## TECHNICAL ADDENDUM No. 1

Tender No: MANPBT0020 DT.06.06.2025

Purchase Specification No: PS-439-1436 Rev 01

FOR TENDER PURPOSE ONLY				PROJECT	
				BALANCE OF SYSTEM PACKAGE FOR DEVELOPMENT OF 900MW (3x300MW) GRID CONNECTED SOLAR PV PROJECT AT FATEHGARH, RAJASTHAN	
				TITLE	
				TYPICAL DETAIL OF ROADS ( Internal / Within Plot)	
PREPARED BY	CHECKED BY	APPROVED BY	DATE	SIZE	REV. NO.
	CIVIL ELE.			A0	
	S

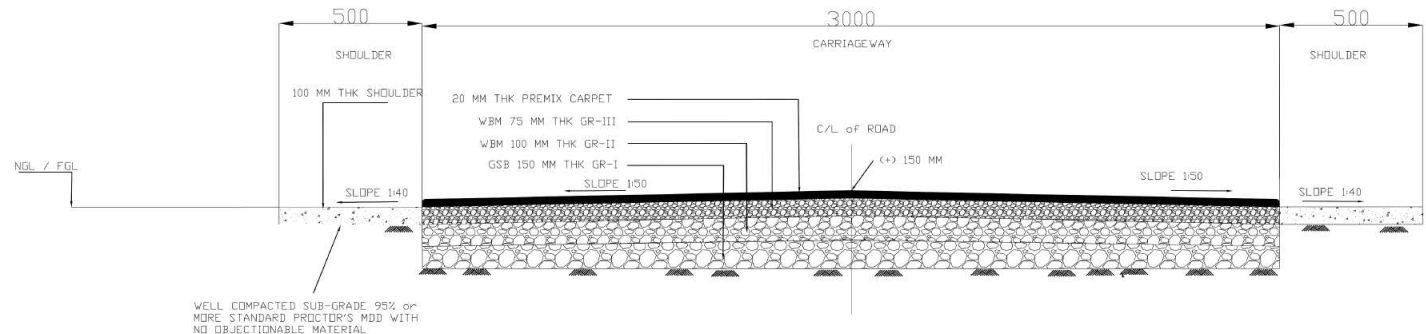
2	Technical Specification Chapter 2-A, Clause 1.0 h)	..... Construction of Store Room – 01 No. per block Construction of 1 No. of store room for each block with minimum built-up size of 250 sqm (width not less than 7Mtr) .....	..... Construction of Store Room – 01 No. per block Construction of 1 No. of store room for each block with minimum built- up size of 250 sqm (width not less than 7Mtr <b>and height not less than 5Mtr</b> )
3	Tender Drawings	Typical Details of Approach and Internal Roads	Drawing revised and enclosed

# TYPICAL CROSS SECTION OF APPROACH & Switchyard ROADS (Inside the Plot)
